# **DCAF Bulletin**

No. 98-8    Issuing Office: CEMP-EC    Issue Date: 8/6/98    Exp. Date: 31 DEC 00

**Subject:       Repetitive Mechanical Observations**

FIGURE 1

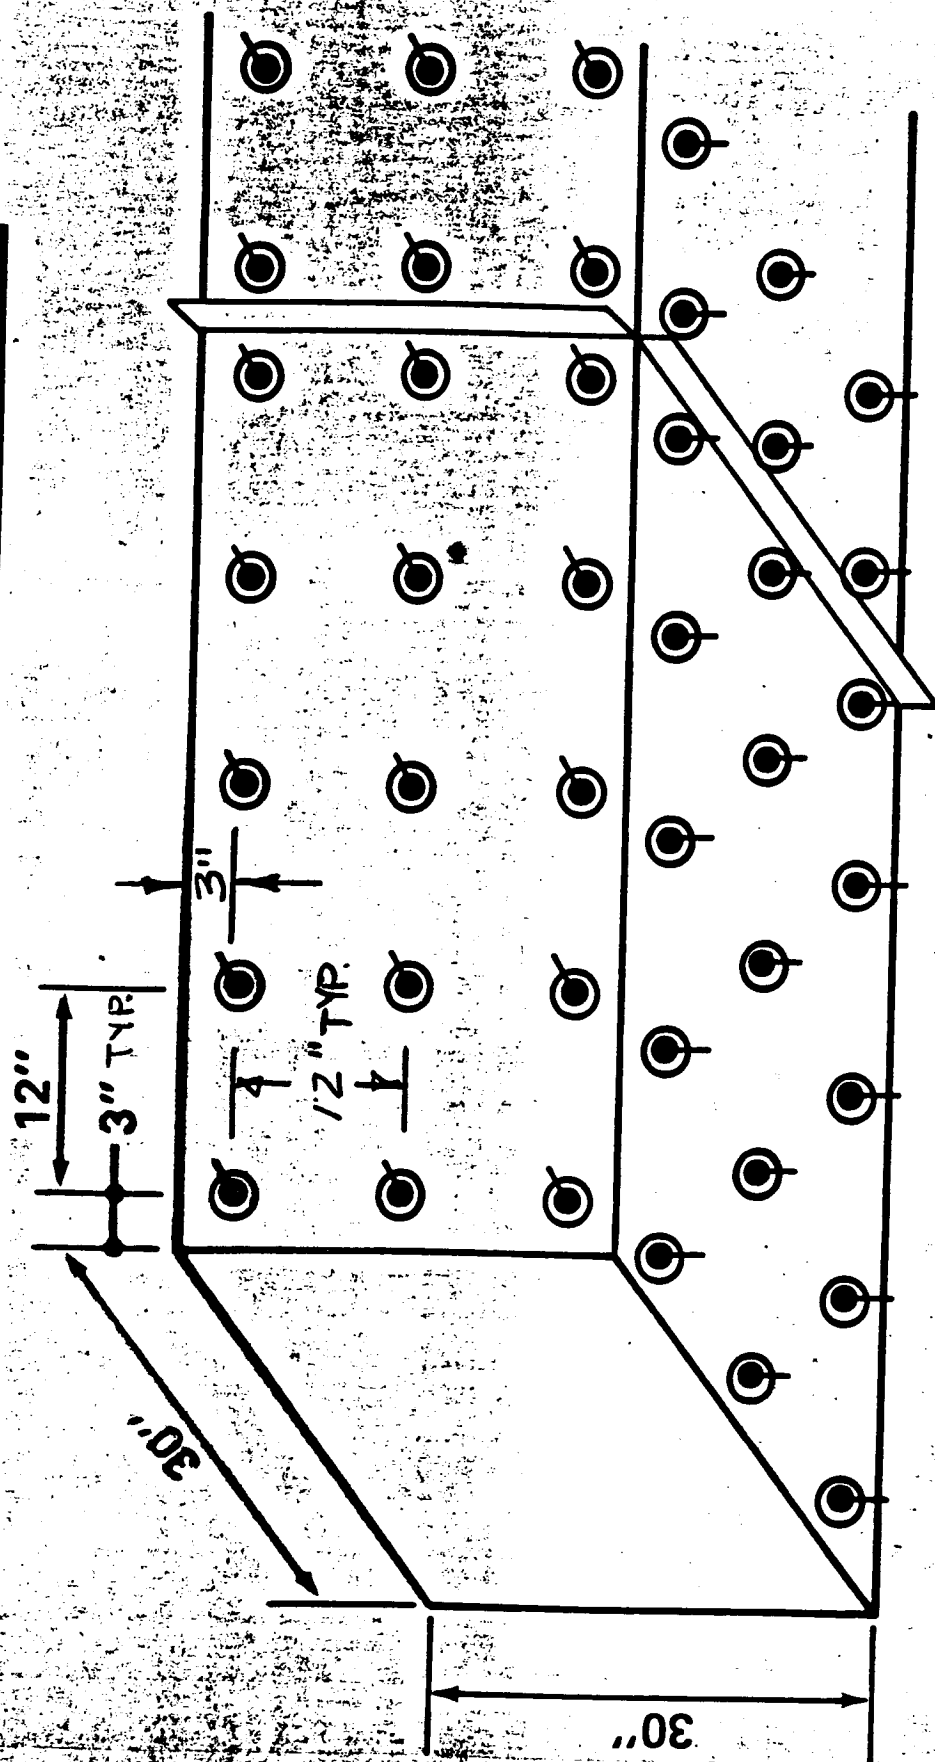
**OBSERVATION:** The mechanical fastener spacing for exposed insulated rectangular duct is not correct.

**REQUIREMENT:** Guide Specification 15250, paragraph 3.3.3.2 (a) requires the rigid insulation shall be secured to the duct by the use of mechanical fasteners on all four sides of the duct, spaced not more than 12 inches apart and not more than 3 inches from the edges of the insulation joints. A minimum of two rows of fasteners shall be provided for each side of duct 12 inches and larger and a minimum of one row for each side of duct less than 12 inches. See figure 1.

FIGURE 2 : EXAMPLE OF A TYPICAL VENT TERMINAL

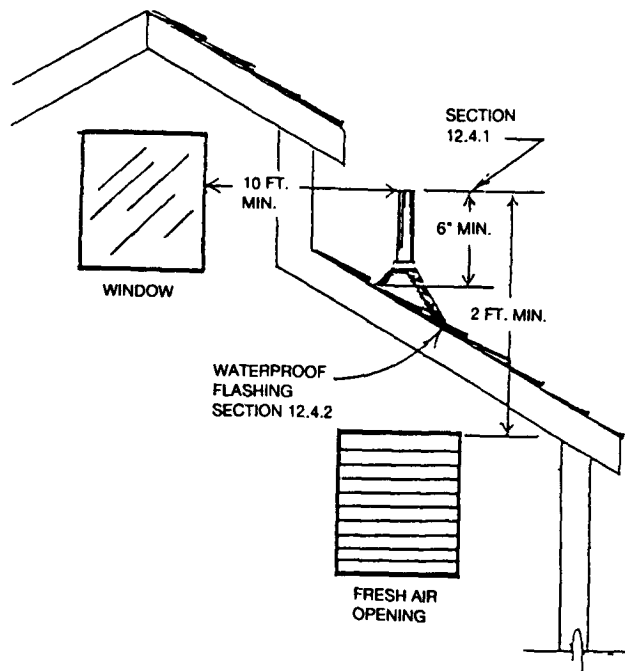
**OBSERVATION:** Plumbing waste vents are terminated too close to building openings.

**REQUIREMENT:** National Standard Plumbing Code 1996 edition paragraph 12.4.4 states "No vent terminal shall be located directly beneath any door, window or other ventilating opening of the building." See figure 2 for proper spacing of vent.

No vent terminal shall be located directly beneath any door, window, or other ventilating opening of the building or of an adjacent building, nor shall any such vent terminal be within 10 feet horizontally of such an opening unless it is at least 2 feet above the top of such opening.

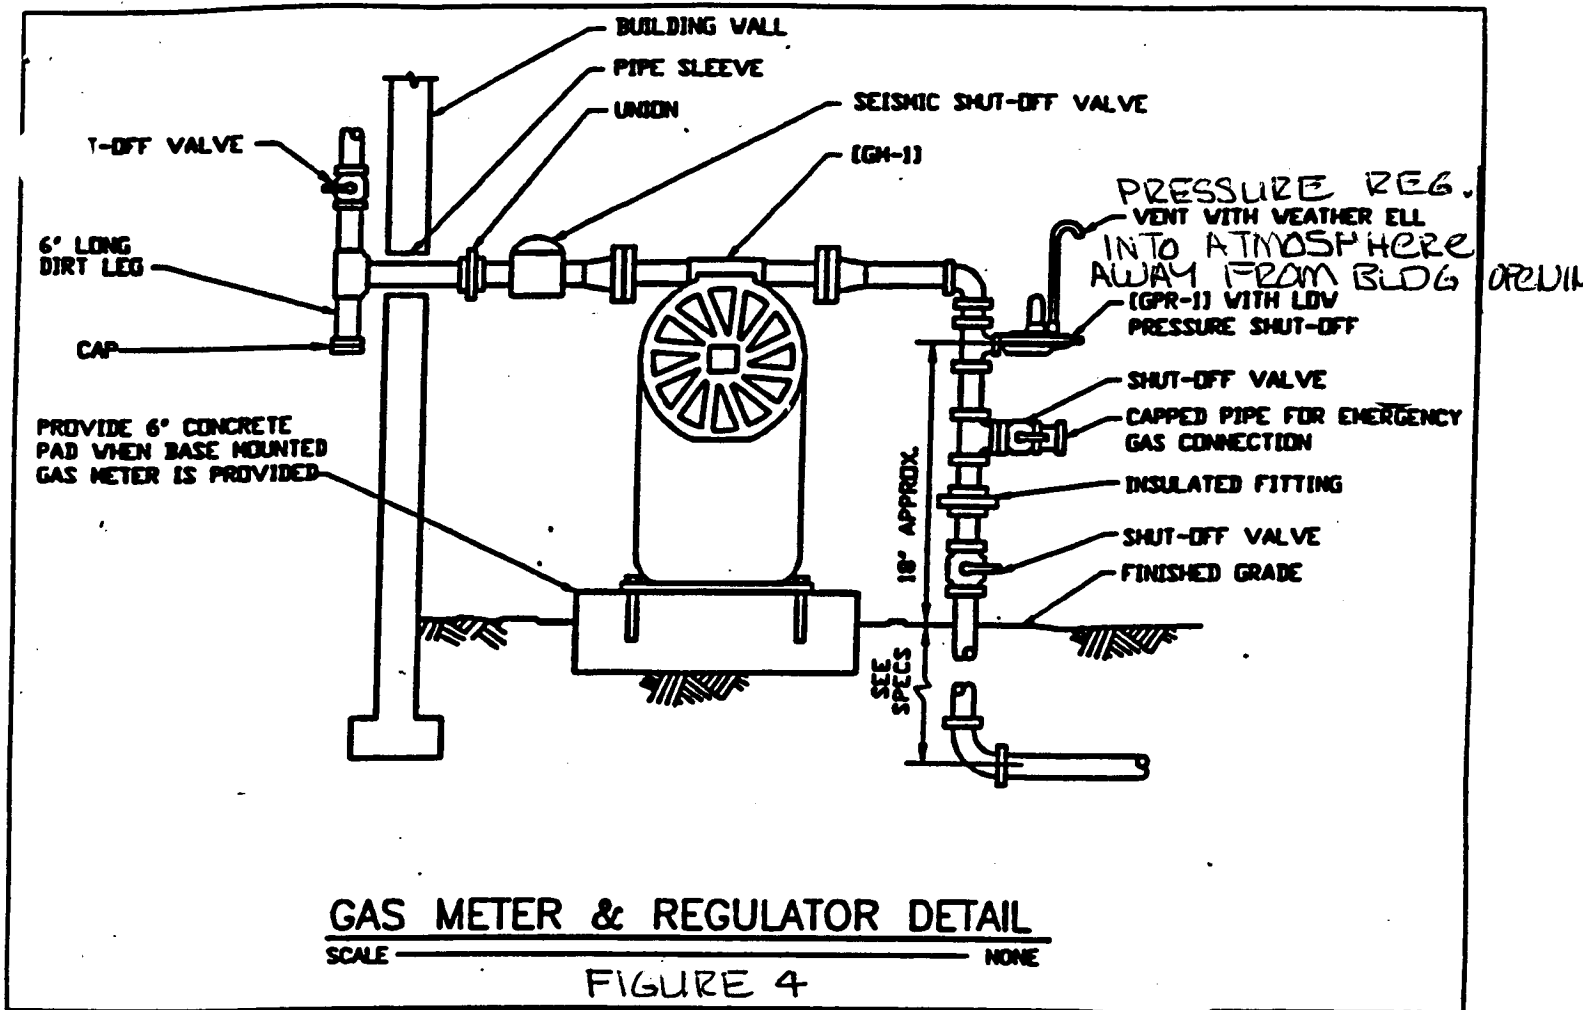
OBSERVATION: Natural gas service regulators are being installed in front of air inlets to buildings. If the regulator diaphragm fails gas could be pulled into building.

REQUIREMENT: Guide specification 02685 requires all service regulator vents and relief vents to terminate in the outside air in rain and insect resistant fittings. The open end of the vent shall be located where gas can escape freely into the atmosphere, away from any openings into the building and above areas subject to flooding. See figure 4.

**FIGURE 5**

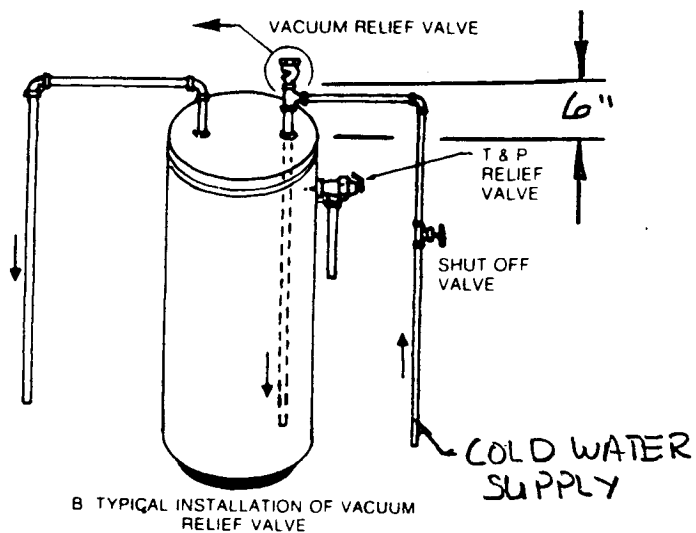
OBSERVATION: A vacuum relief valve is not being installed in the cold water supply line to hot water storage tanks or water heaters.

REQUIREMENT: Guide specification 15400 requires a vacuum relief valve to be provided on the cold water supply line to the tank and mounted above and within 6 inches above the tank. See figure 5.

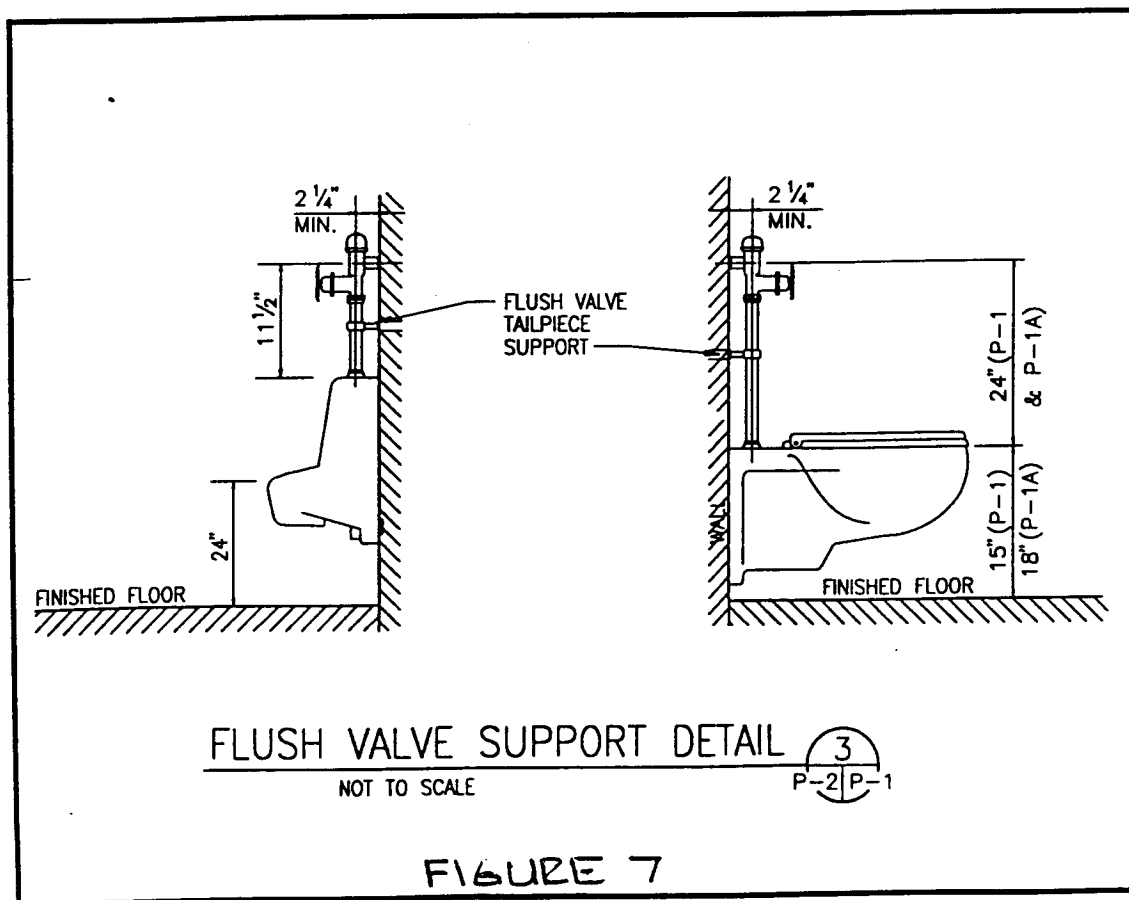
OBSERVATION: Some contractors are not installing a service stop and drain valve in the building water service just inside the building.

REQUIREMENT: Guide specification 15400 paragraph 3.1 requires a gate valve or full port ball valve and drain to be installed on the water service line inside the building approximately 6 inches above the floor from point of entry. See figure 6.

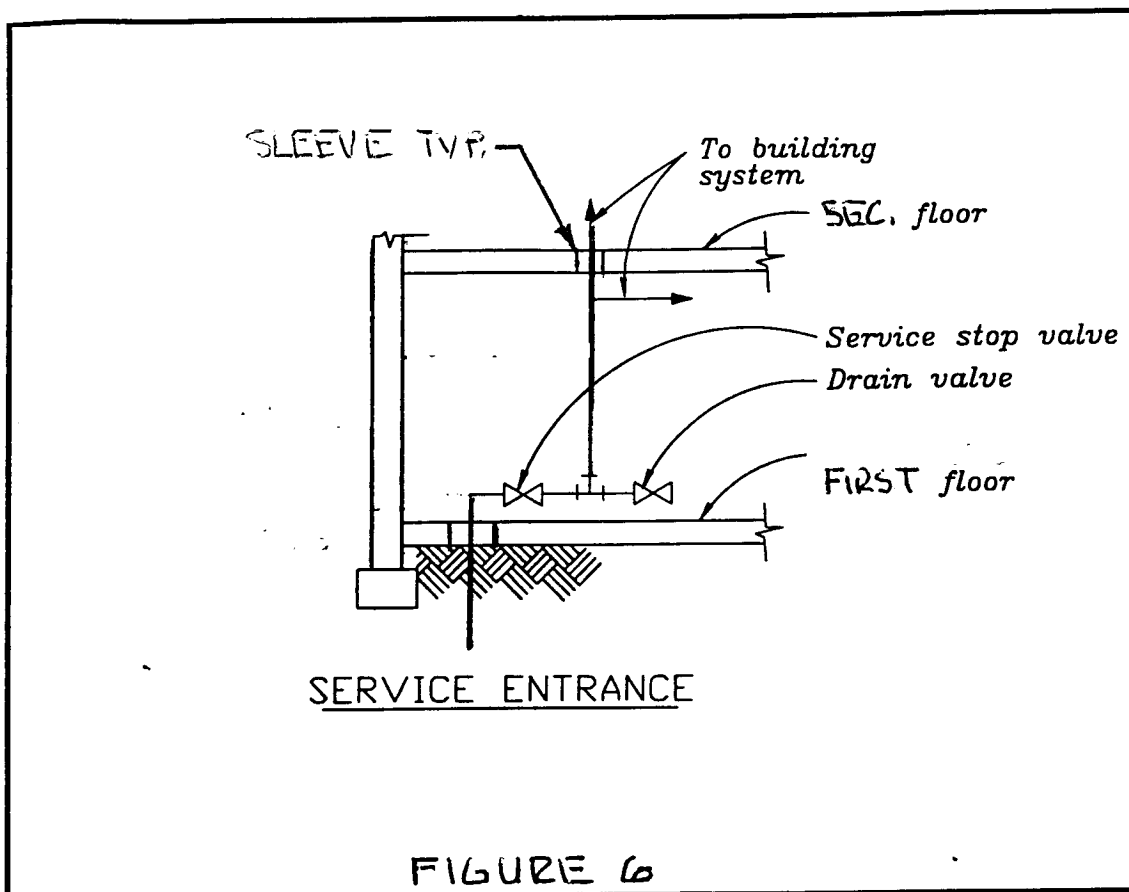
OBSERVATION: Flush valves are being installed at the wrong height and without proper support.

REQUIREMENT: Guide specification 15400 requires flushometer valves to be secured to prevent movement by anchoring the long finished top spud connecting tube to wall adjacent to valve with approved metal bracket. Flushometer valves for water closets shall be installed 39 inches above the floor. See figure 7.

FIGURE 8

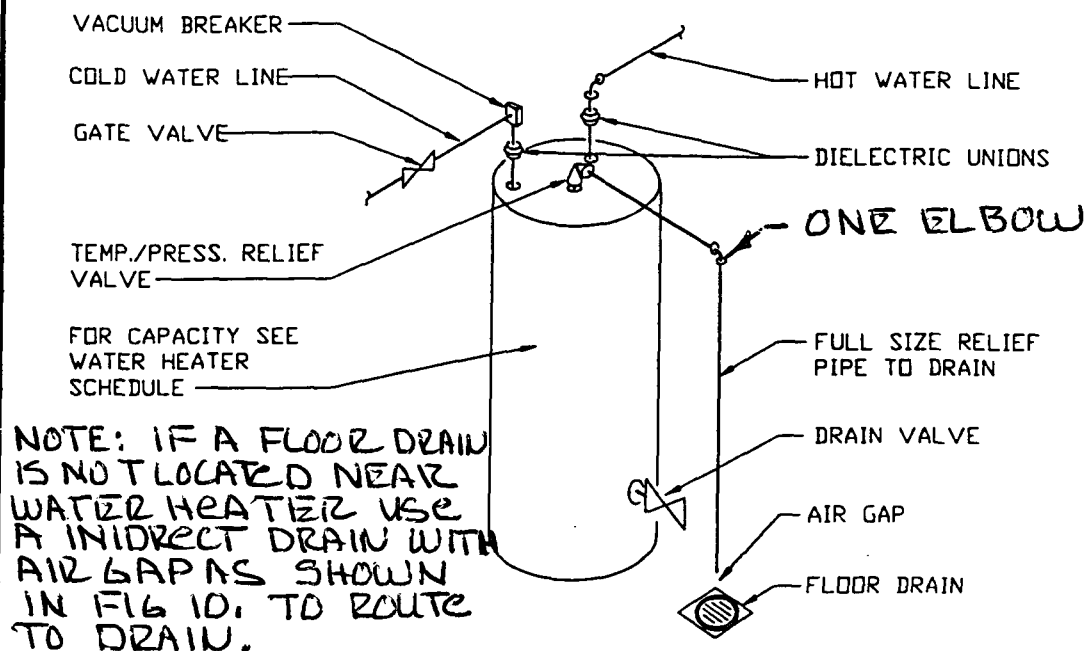
OBSERVATION: During construction backflow preventers are being installed with a valved bypass around it. Also, some designers are showing the valved bypass on the backflow preventer detail. The bypass has a valve installed for isolating the backflow preventer for maintenance. If the valve is opened contamination of the potable water system is possible.

REQUIREMENT: The National Standard Plumbing Code 1996 edition paragraph 10.4.3 requires each potential cross connection within the premises shall be protected. The valved bypass around the backflow preventer is a potential cross connection. If a bypass is required then require a backflow preventer in the bypass. Contractors shall not install a valved bypass and designers shall not show a valved bypass on the backflow preventer detail. See figure 8 for proper installation of backflow preventer.

FIGURE 9

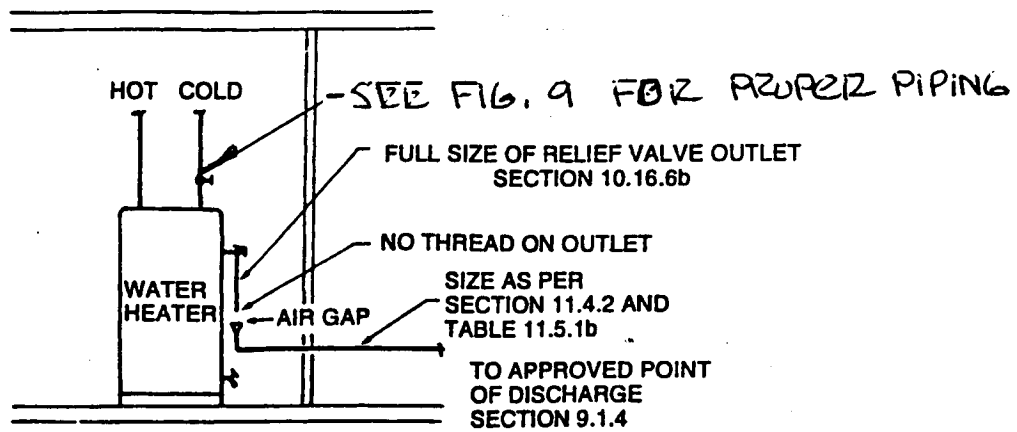
OBSERVATION: Piping from the outlet of relief valves for water heaters have multiple elbows in the discharge piping with several changes in direction as the piping is being routed to the floor drain. Where two or more relief valves serving independent systems are located in the same area the discharge piping is being combined into a common line routed to drain.

REQUIREMENT: The National Standard Plumbing Code edition 1996 paragraph 10.16.6 (c) requires the discharge pipe to be no smaller than the outlet size of its relief valve and shall extend to a point of disposal without valves, traps or rises that would prevent the relief valve from draining by gravity. Discharge end of the pipe shall not be threaded. Section 4, Part HLW-800 of the ASME Boiler and Pressure Vessel Code covers the safety valve requirements for water heaters and Article 8 paragraph HLW-801.7(a) states "When an elbow is placed on a safety relief discharge pipe, it shall be located close to the valve outlet." This indicates only one elbow is allowed in the discharge piping and it shall be located close to the relief valve outlet. The National Standard Plumbing Code edition 1996 paragraph 10.16.6 (g) states "If the point of disposal is outside the room or space in which the relief valve is located, an indirect gravity drain shall be provided from the room or space to the point of disposal." See figures 9 and 10.

FIGURE 11

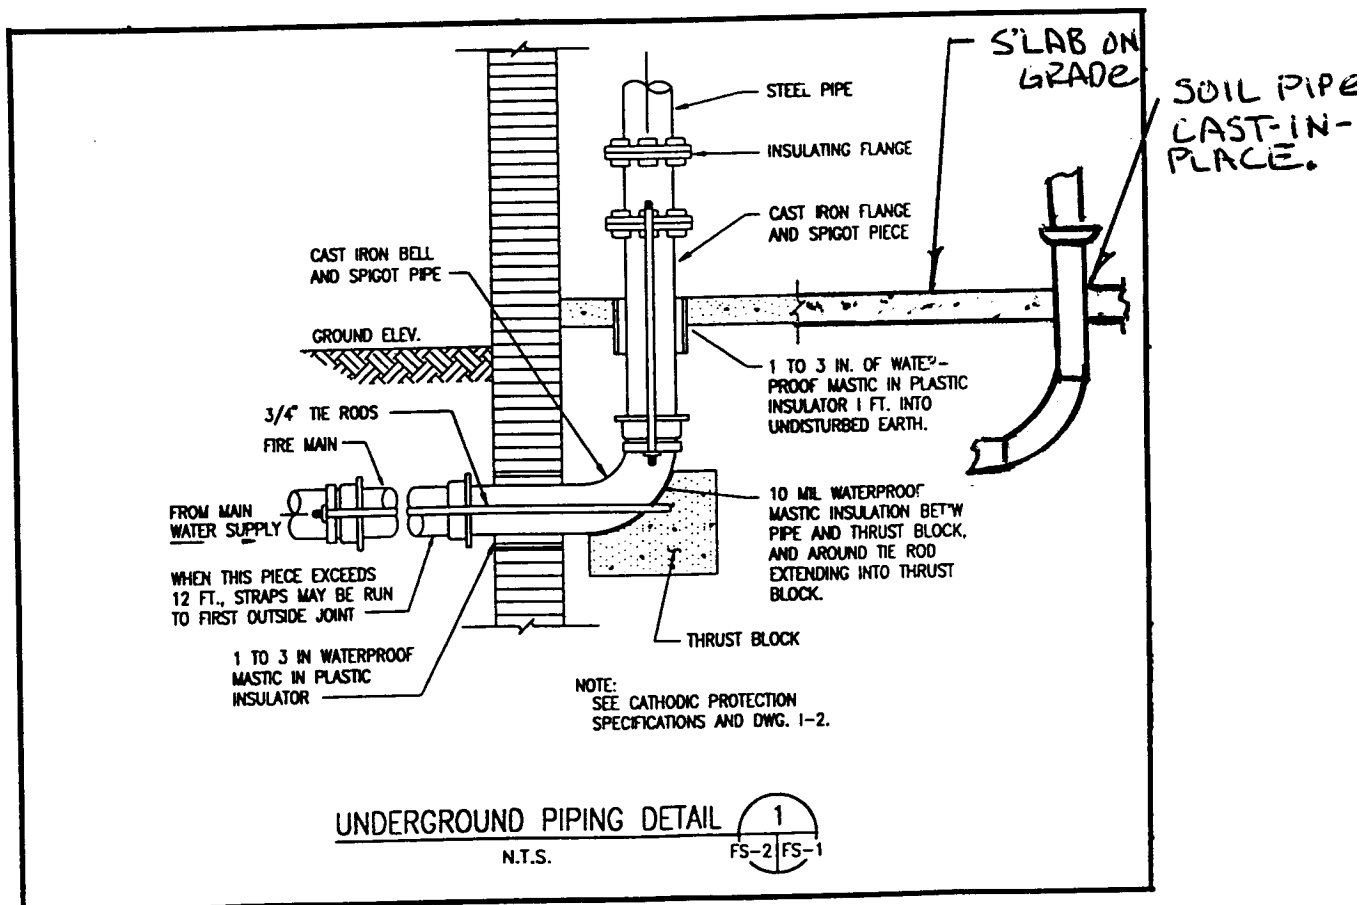
OBSERVATION: Frequently pipes and or tie rods penetrating concrete slabs on grade are cast directly into the slab. If a sleeve is provided many installations have the tie rods outside the sleeve and cast directly into the slab.

REQUIREMENT: Guide Specification 15400 paragraph 3.1.6.1 requires a sleeve for all pipes passing through all concrete floors or walls except sleeves are not required for cast-iron soil pipe passing through concrete slab on grade, except where penetrating a membrane waterproof floor. All other pipe penetrations and tie rods shall be inside the sleeve at each concrete slab penetration. See figure 11.
